Access Compliance Report

Public Rights-of-Way

(Curb Ramps)

Intersection ID: 10035178	Main Street: QUAIL_HOLLOW_RD	Cross Street: N/A	Location: NW
ADA ID: DEA04D2D3638	Ramp Type: PerpDiag	Initial Pass/Fail: Fail	Overall Compliance: No
			Severity Score: 13.75

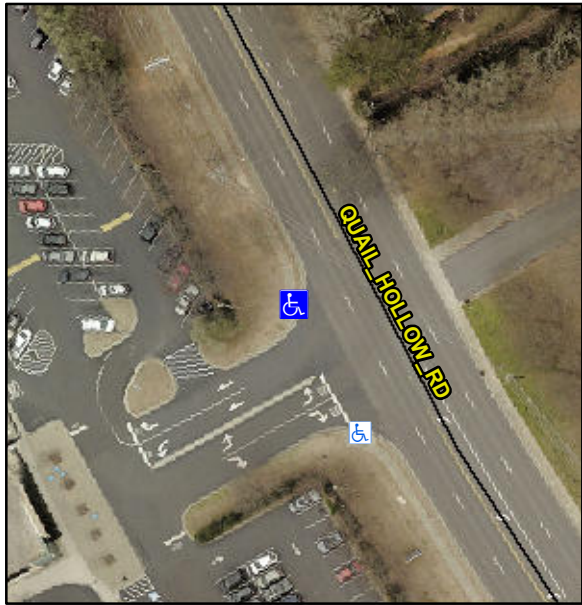
Codes/Mitigation Info/Possible Solution			Field Measurements/Component Compliance					
	Possible Solutions:		Compliance	Description	Data	Compliance	Description	Data
	Remove & Replace Curb Ramp With Two New Directional Ramps or Equivalent.		N/A	Ramp Length (in)	96.0	No	Ramp Slope (%)	9.1
			Yes	Ramp Width (in)	48.0	No	Ramp XSlope (%)	2.2
			N/A	Flare Type LT	N/A	N/A	Flare Type RT	N/A
			N/A	Flare Slope LT (%)	N/A	N/A	Flare Slope RT (%)	N/A
			N/A	Flare Traversable LT?	N/A	N/A	Flare Traversable RT?	N/A
			N/A	Landing Length (in)	N/A	N/A	DWS Provided?	N/A
			N/A	Landing Width (in)	N/A	N/A	DWS Contrast?	N/A
			N/A	Landing Slope (%)	N/A	N/A	DWS Length (in)	N/A
			N/A	Landing X Slope (%)	N/A	N/A	DWS Full Width?	N/A
Surveyor Notes:		N/A	N/A	Landing Curb? (Y/N)	N/A	N/A	DWS Offset (in)	N/A
PROW/ADA:			N/A	Shared Landing?	N/A			
Not Found, R304.2.2, R304.5.3			N/A	Gutter Ponding?	N/A	N/A	Gutter Slope (%)	N/A
			N/A	Gutter Lip Ht (in)	N/A	N/A	Gutter X Slope (%)	N/A

N/A	Painted X Walk1?	No	N/A	Painted X Walk2?	No
				X Walk 1 Direction	To SE		X Walk 2 Direction	To NE
			N/A	X Walk 1 Width (in)	N/A	N/A	X Walk 2 Width (in)	N/A
				X Walk 1 Slope (%)	2.3		X Walk 2 Slope (%)	1.2
				X Walk 1 X Slope (%)	1.0		X Walk 2 X Slope (%)	1.1
			N/A	Ramp inside XWalk1?	N/A	N/A	Ramp inside XWalk2?	N/A
				Road Slope (%)	2.0	N/A	Clear Space?	N/A
				Road X Slope (%)	1.7	N/A	Clear Space to XWalk (in)	N/A
			N/A	Any Obstructions?	N/A	N/A	Storm Grate/Utility Hazard?	N/A
				Obstruction Type			Storm Grate/Utility Type	
					N/A			N/A
						Yes	Surface Condition? (G/P)	Good
Street 1 Name		ENTRANCE						
Stop Condition-Street 1		StopSign						
Street 2 Name		QUAIL HOLLOW RD						
Stop Condition-Street 2		None						
Total Cost:		\$ 3200.00
